Québec–New Hampshire Interconnection

**Hydro-Québec TransÉnergie (HQT) responses to the National Energy Board's Request
for Information **No. 2** dated July 10, 2017**
July 24, 2017

Drawing of Crossing Structure

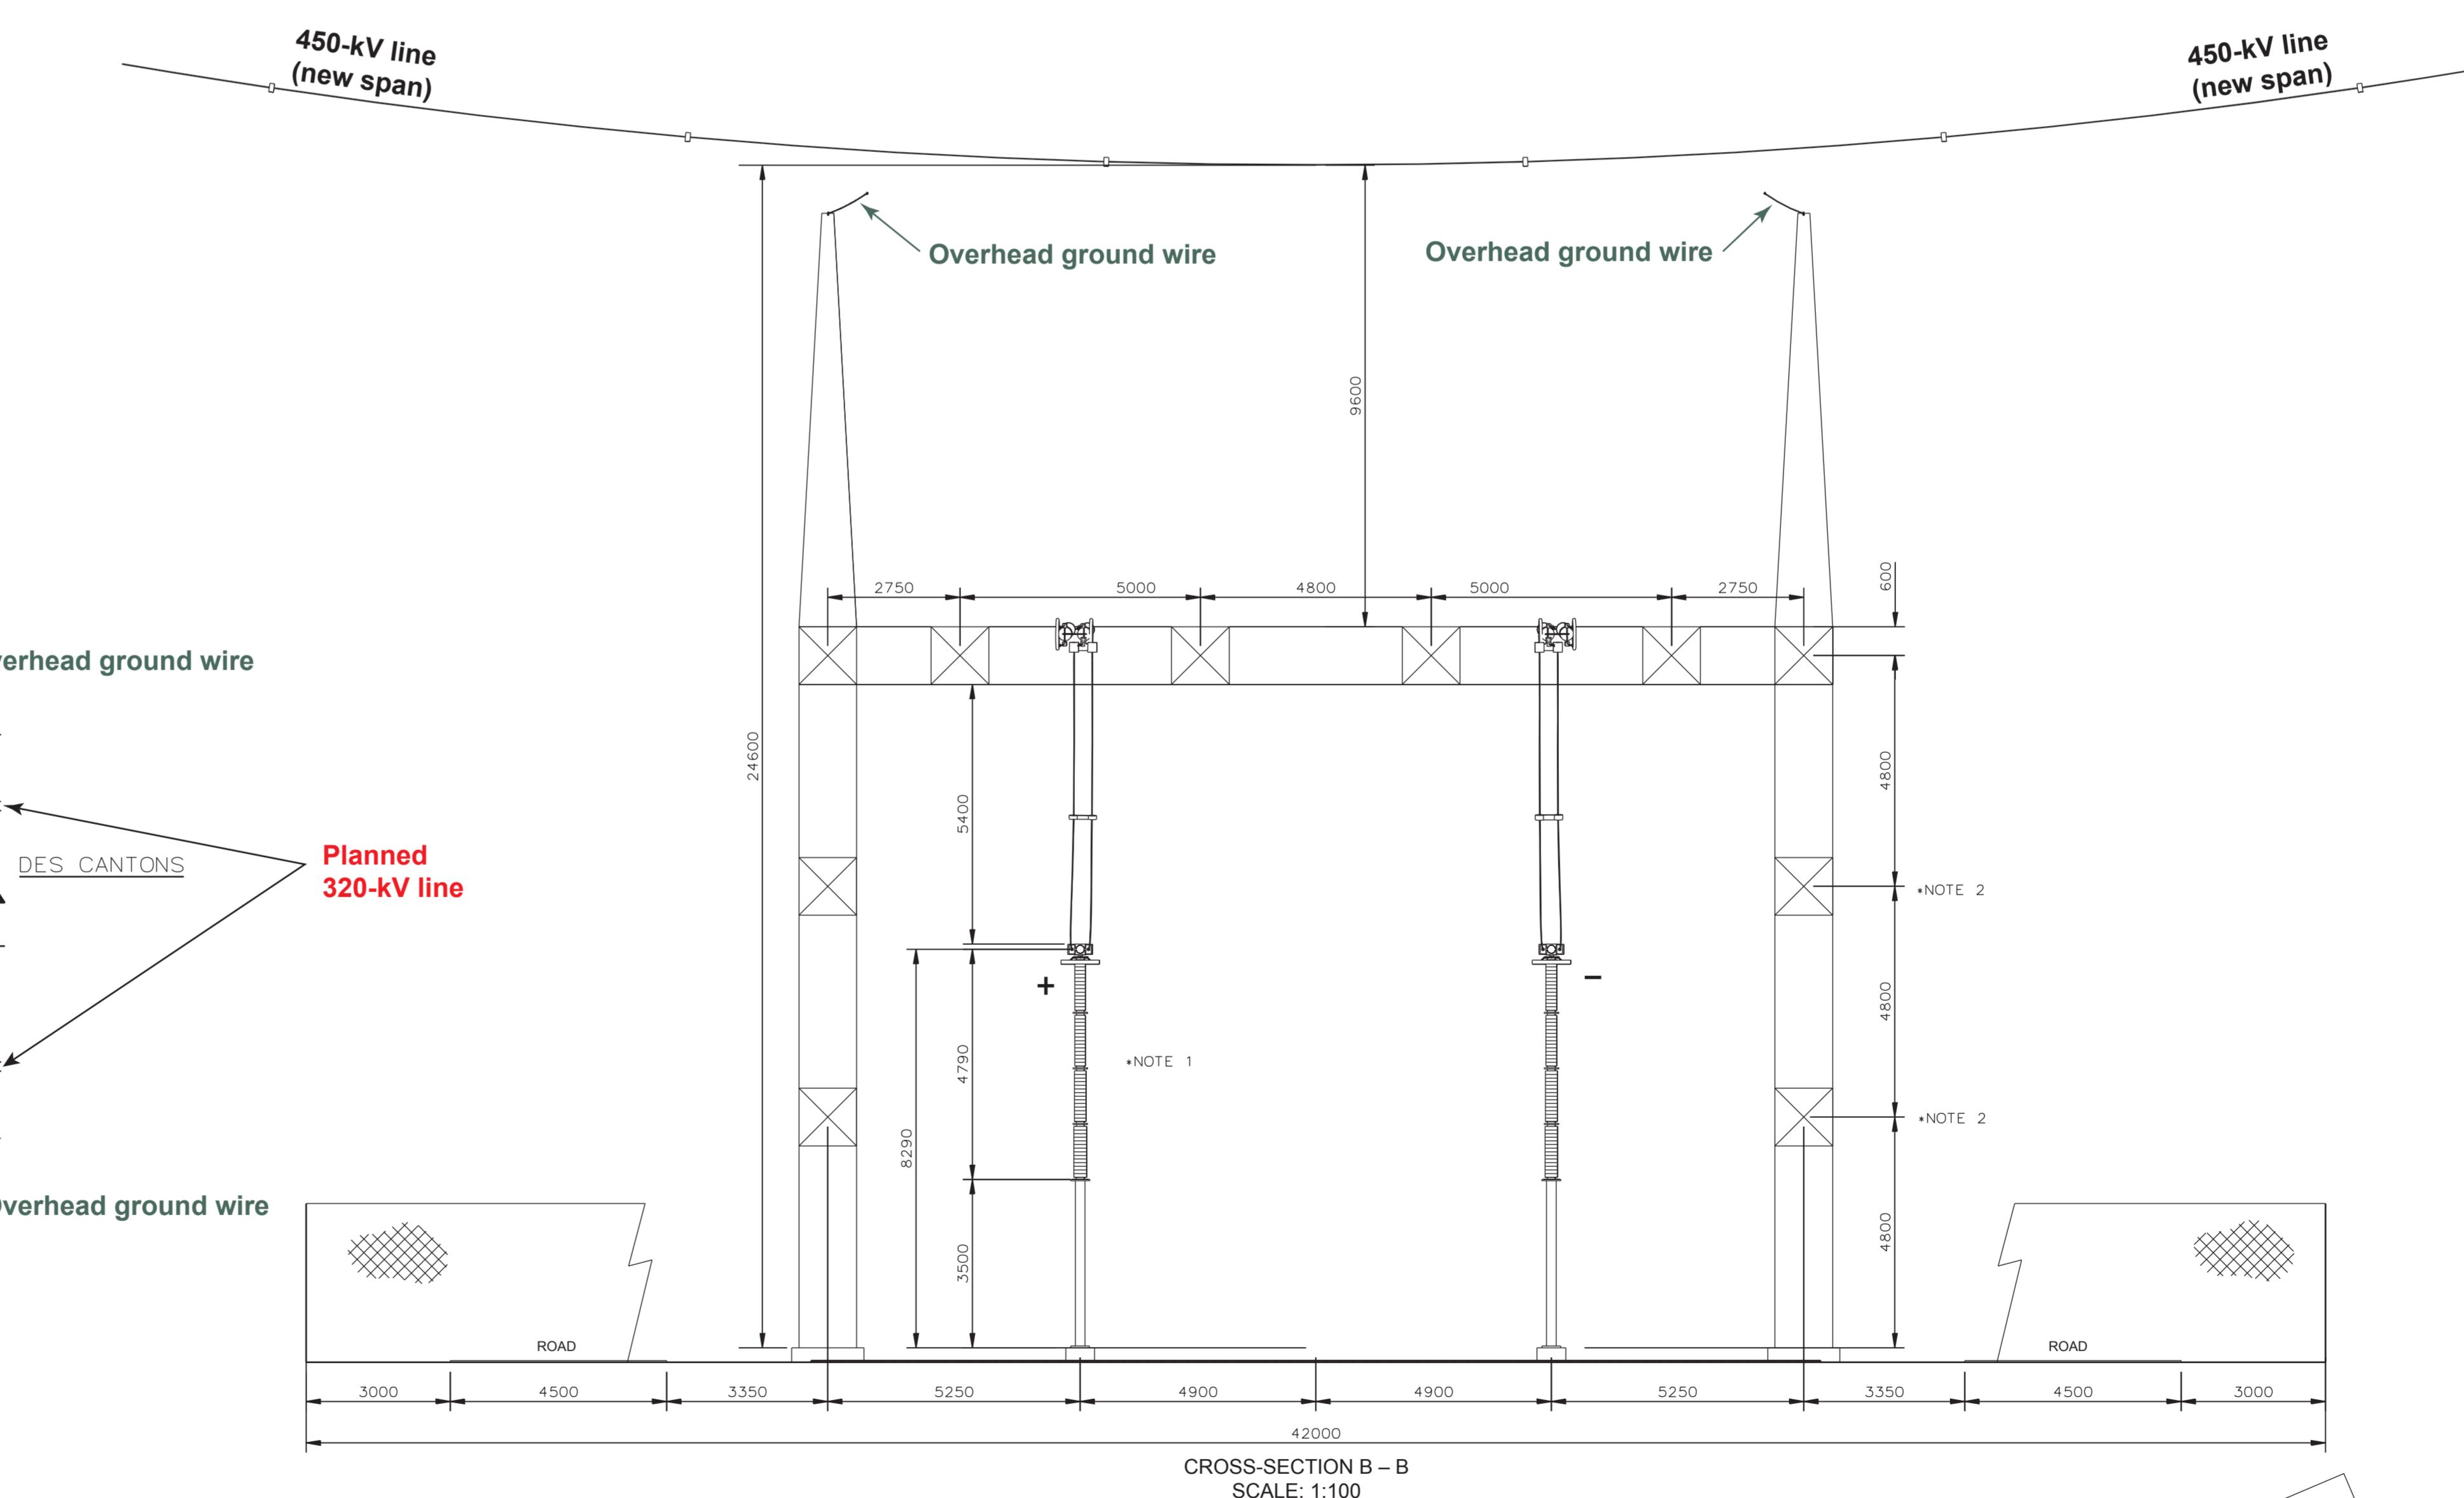
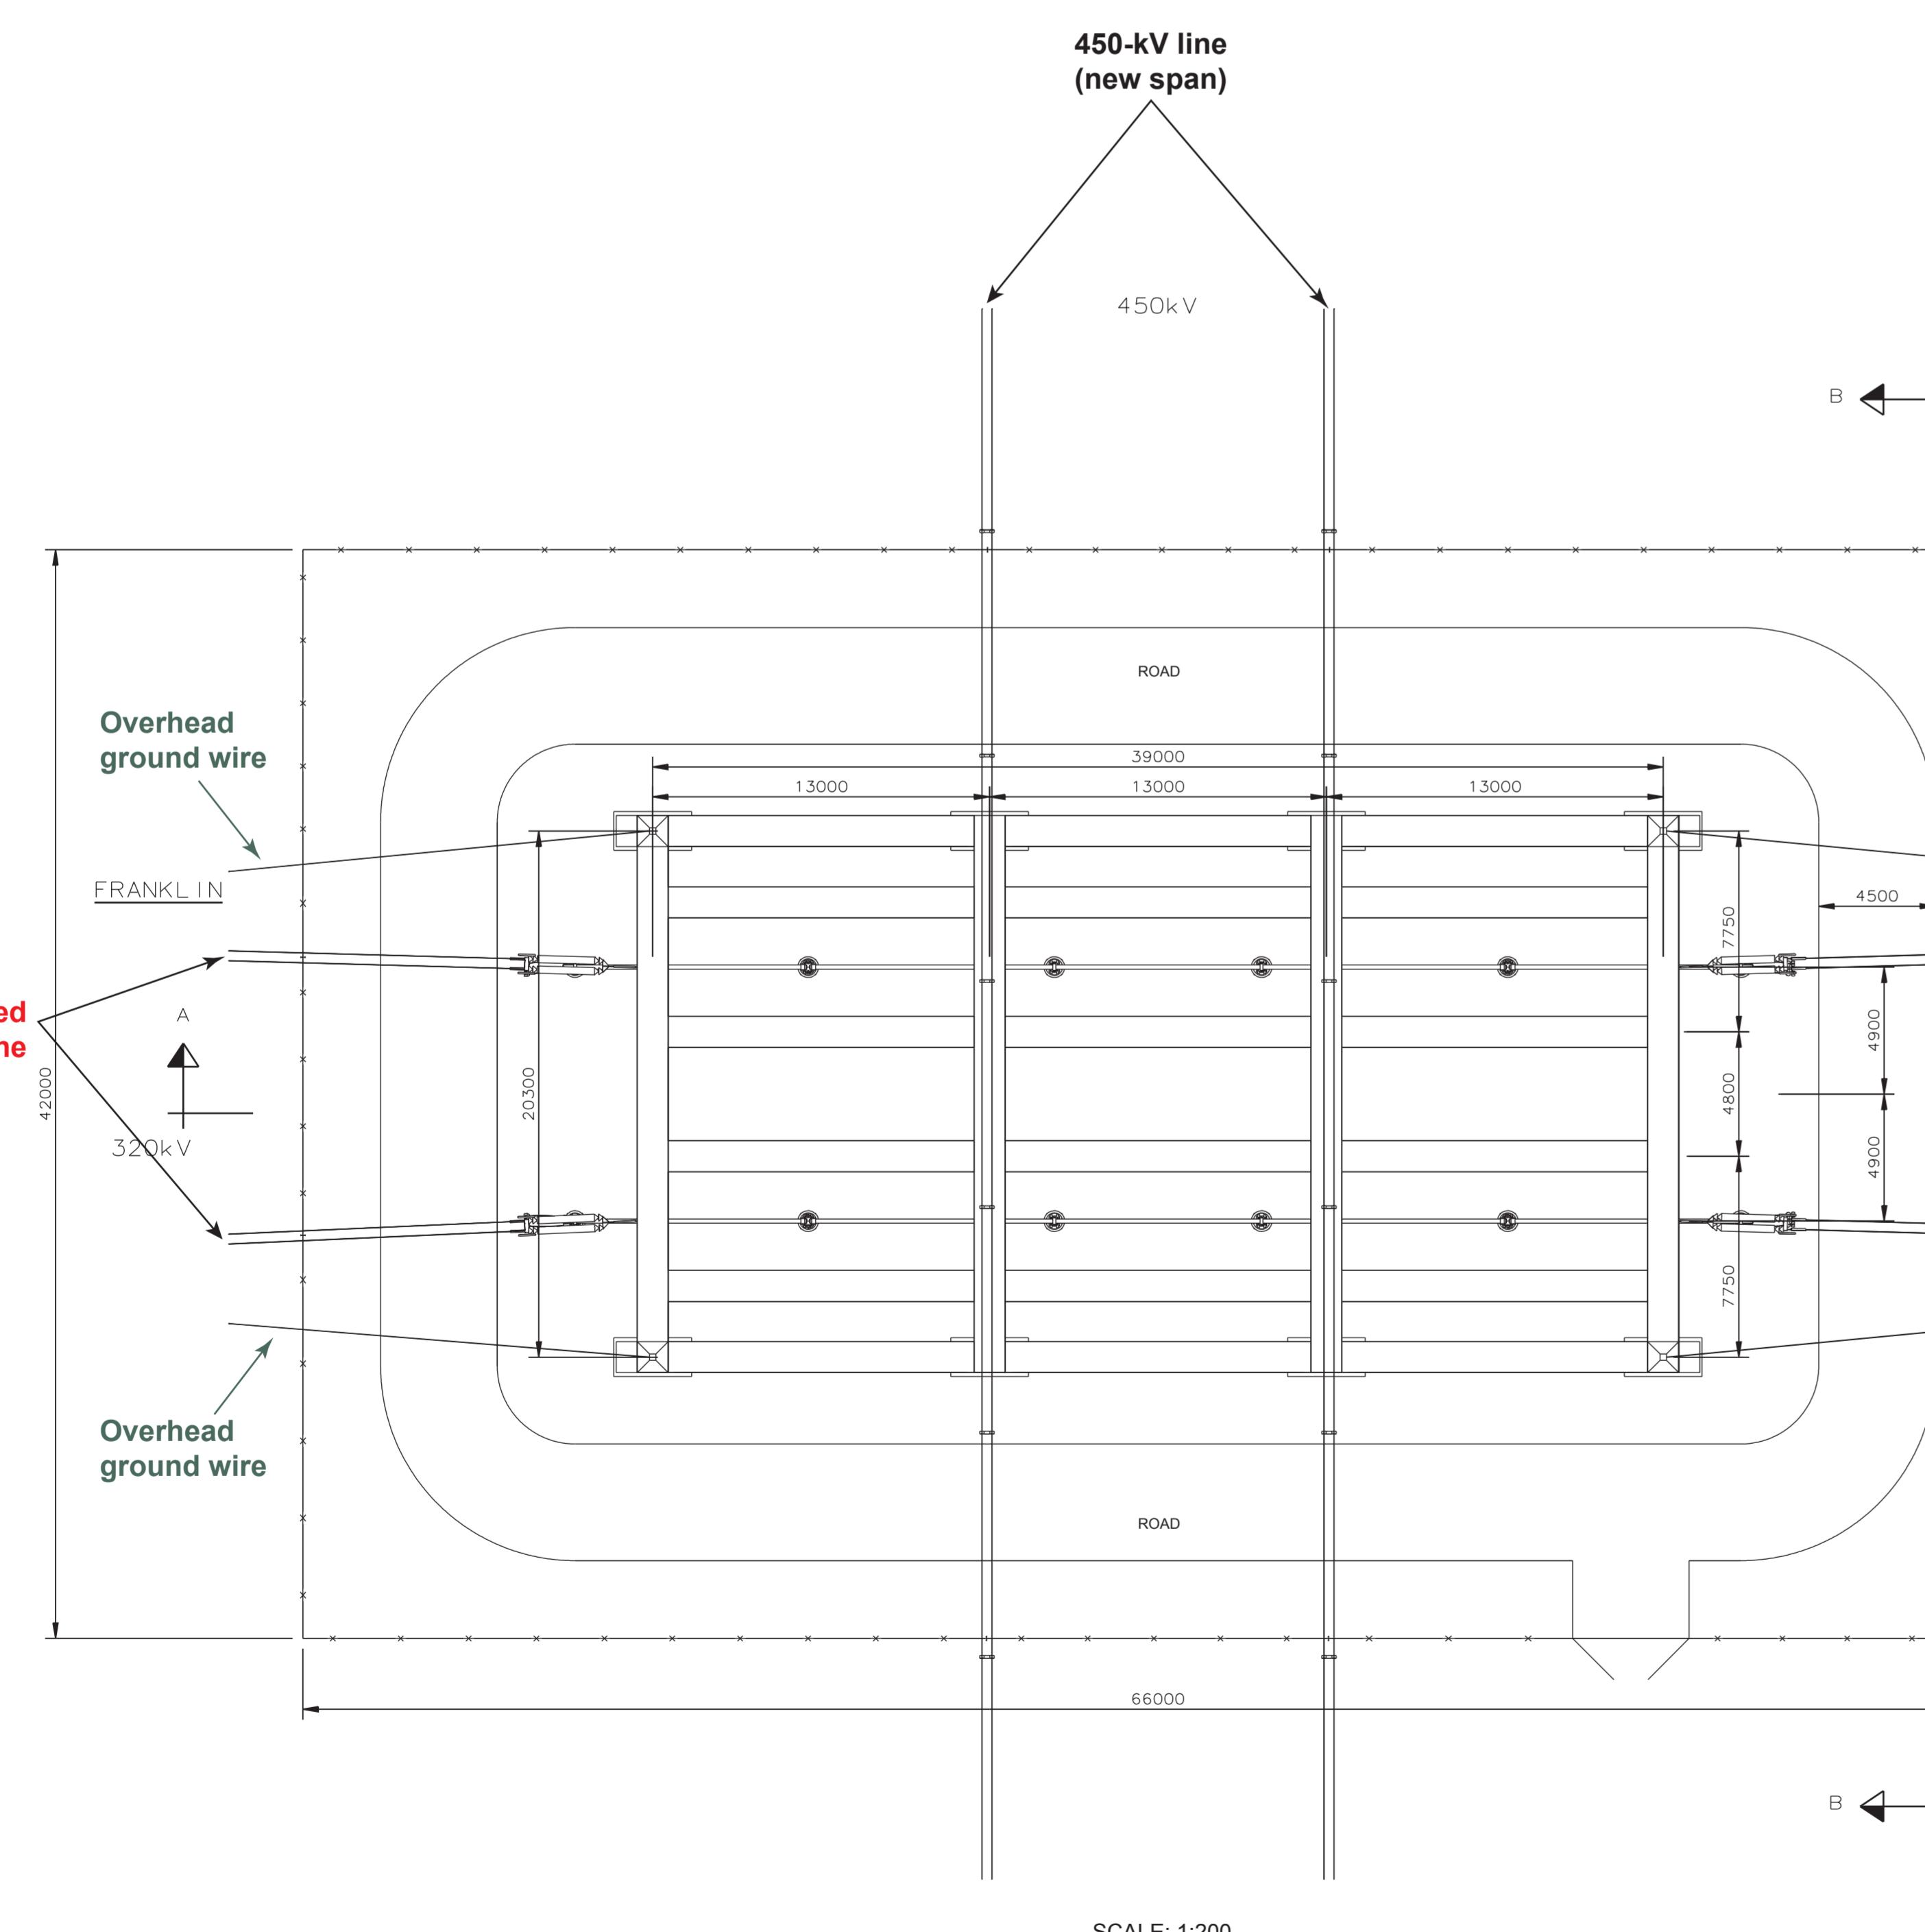
- a) A revised drawing with isometric view showing the following additional components:
 - a.1) The 450 kV line; and
 - a.2) Labels identifying both the 450 kV and 320 kV lines.

Answer 2.3 a) *The drawing provided in Appendix B shows an isometric view and an electrical layout plan of the crossing structure, as well as two cross-sectional views, each of which includes labels clearly identifying the 450-kV and 320-kV lines.*
